# TECHNICAL INFORMATION

- Subject** ▶ Modification of D-Shaped Side Handle
- For Models** ▶ HM1100C, HM1140C, HM1200K, HM1211B, HR4000C, HR5001C
- Country** ▶ All countries
- Description** ▶ Some components of D-Shaped Side Handle have been modified in order to enhance its durability as illustrated below.

## HM1100C, HM1140C, HM1211B

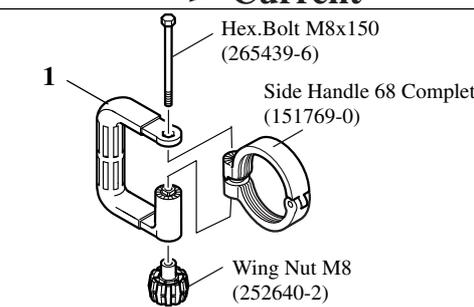
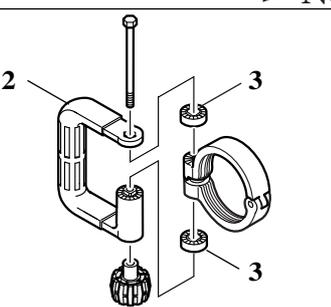
▶ Current	▶ New
 <p>1. Handle Spring 60 (344559-0) Material: Sheet Metal</p> <p>2. Handle Base 60 (416396-3) [2 pcs.] Material: Resin</p> <p>3. Side Handle (416009-6)</p> <p>Hex. Bolt M8x150 (265439-6)</p> <p>Wing Nut M8 (252640-2)</p>	 <p>4. Side Handle Base 60 Comp. (152620-7) Material: Aluminum</p> <p>5. Side Handle (417003-1)</p> <p>6. Side Handle Cam (417002-3) [2 pcs.]</p> <p>Hex. Bolt M8x150 (265439-6)</p> <p>Wing Nut M8 (252640-2)</p>
<p>Side Handle Assembly (134793-8) It consists of the six parts illustrated above.</p>	<p>Side Handle Assembly (134909-5) It consists of the six parts illustrated above.)</p>

## HM1200K

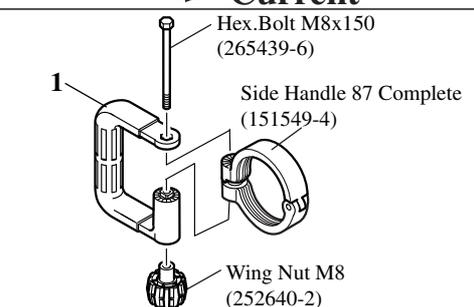
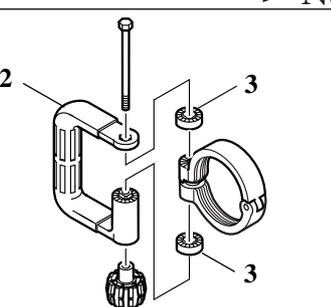
▶ Current	▶ New
 <p>1. Side Handle (416009-6)</p> <p>Hex. Bolt M8x150 (265439-6)</p> <p>Wing Nut M8 (252640-2)</p> <p>Handle Base 48 (416397-1)</p> <p>Handle Spring 48 (344560-5)</p> <p>Handle Base 48 (416397-1)</p>	 <p>2. Side Handle (417003-1)</p> <p>3. Side Handle Cam (417002-3) [2 pcs.]</p> <p>Hex. Bolt M8x150 (265439-6)</p> <p>Wing Nut M8 (252640-2)</p>
<p>Side Handle Assembly(134794-6) It consists of the six parts illustrated above.</p>	<p>Side Handle Assembly (134944-3) It consists of the eight parts illustrated above.</p>
